PRODUCT/PROCESS CHANGE NOTICE (PCN)

PCN #: L-0607-01R1 DATE: 6-Oct-06 Product Affected: Please see the attached list of the affected products shipped in tape and reel, and in tubes Date Effective: 6-Oct-06	MEANS OF DISTINGUISHING CHANGED DEVICES: <input type="checkbox"/> Product Mark <input type="checkbox"/> Back Mark Lot shipments will have Level 1 <input checked="" type="checkbox"/> Date Code Moisture Sensitive Label, and with <input type="checkbox"/> Other date code starting "0630".
---	---

PCN Type: Change in Moisture Sensitivity Level

From: MSL 3 Moisture Sensitive Label

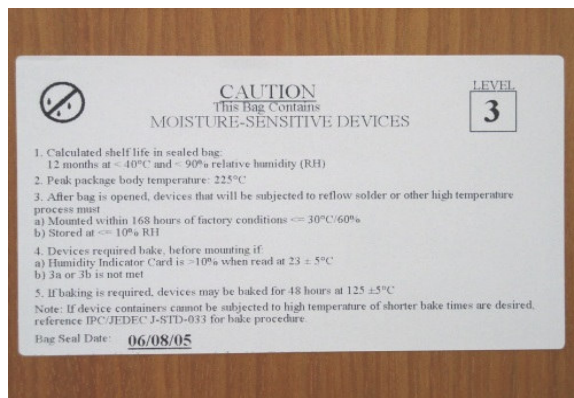
Data Sheet Change: There is change in Moisture Sensitive Level (MSL) from 3 to 1.

This notification is to advise customers that IDT is converting ICS MSL 3 products shipped in tape and reel, and in tubes, to MSL 1. IDT has completed the verification of the moisture sensitivity classification of ICS products to MSL 1.

The affected products will be shipped without dry pack and labelled as MSL 1 according the JEDEC J-STD-033. There is no change to the assembly material set and the peak reflow temperature. Please refer below for the examples of moisture sensitive labels.

To: MSL 1 Non-Moisture Label

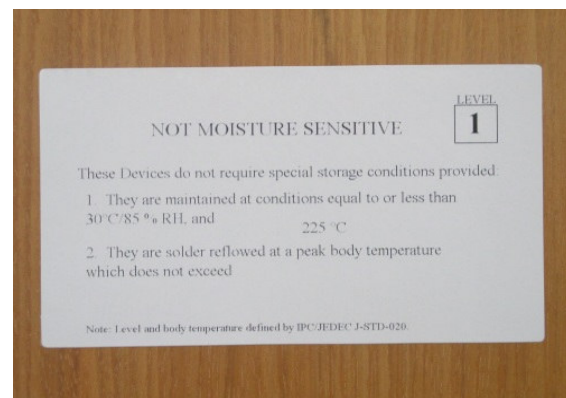
Note: There is no change to the peak reflow temperature of the affected products.
